Development licence assessment report

Application No.	APP001686
Applicant Name	Water Sustainability Farm Pty Ltd
Registered address	1324 Blue Ribbon Road Kalkee Victoria 3401 Australia
Development activity, address and proposal	A04 Industrial Wastewater Treatment Lanes Avenue, Quantong <ul style="list-style-type: none">Construct two solar drying evaporation basins for the processing of brine waste a food manufacturing by-product.

Assessment report number: PAS006550

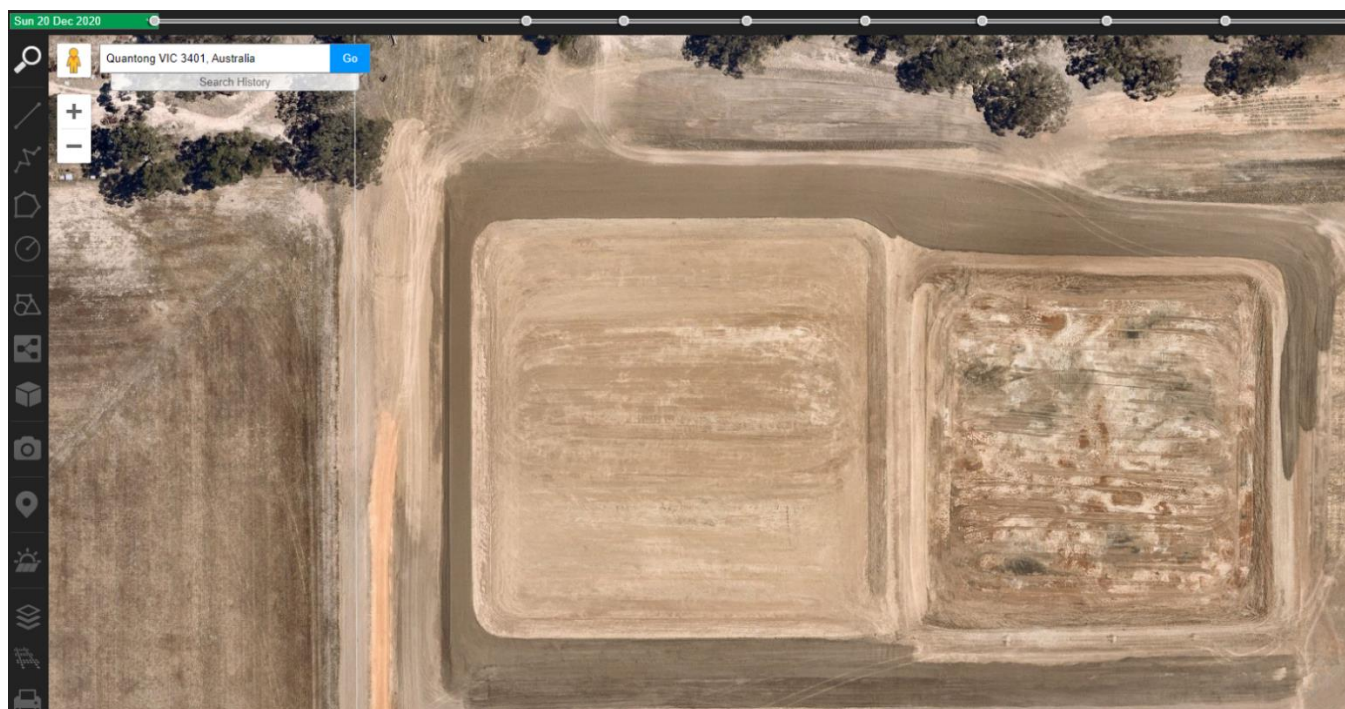
Scott Sandercock, a senior EPO conducted an inspection of the dam which have been constructed prior to the development application. The inspection revealed cracks and rills in the basin walls, the floor of the basin was compacted clay, but it had dried out leading cracking in the floor of the basin. In addition to this, weed and plant growth has occurred, further compromising the clay liner.

Photos 1-4 illustrate the type of cracking and vegetation growth that presently exist in the evaporation basin.

Photograph 5 - Aerial photograph 20/12/2020

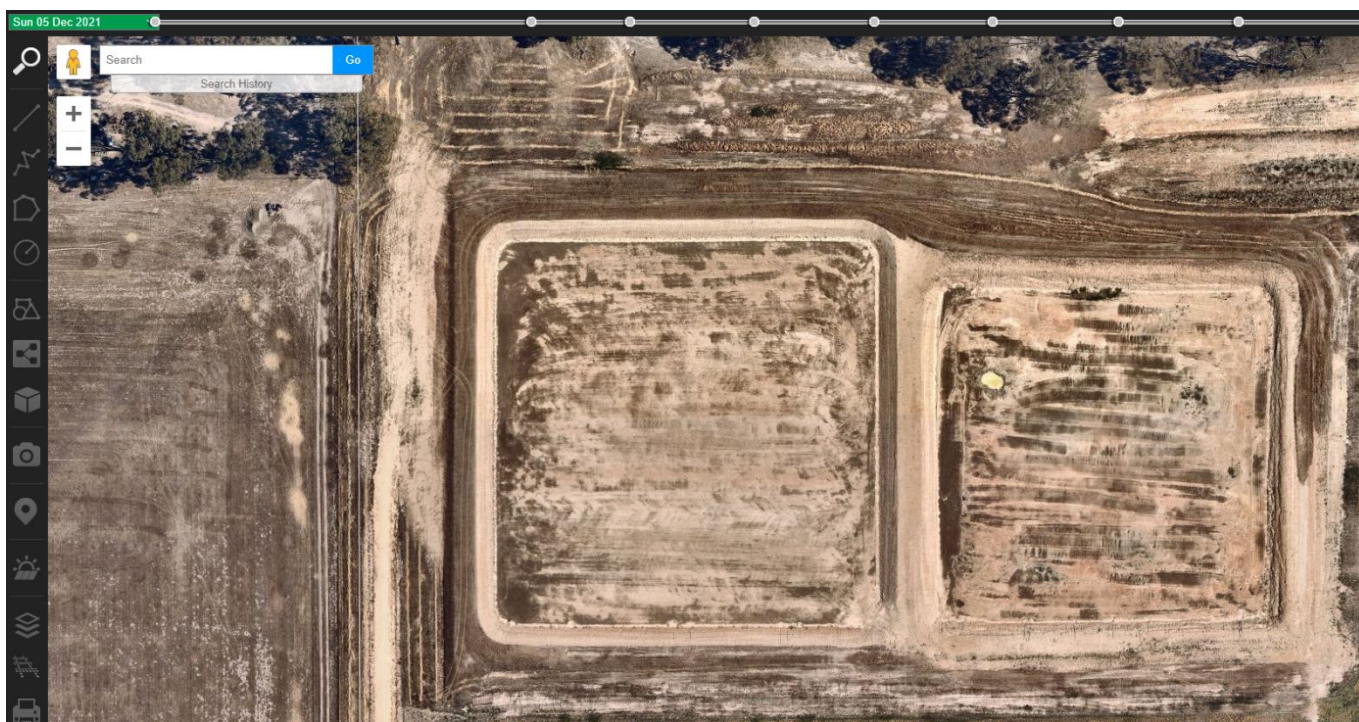
Furthermore, Photo 5 & 6 show aerial images of the evaporation basin taken in Dec 2020 and Dec 2021 respectively, these images seem to indicate a potential subsidence in the NW corner of the eastern evaporation basin, indicating a likely risk relating to the structural integrity of basin floor.

Based on these observations, the region is concerned that the existing basin will not achieve the specified permeability outlined in the proposal.
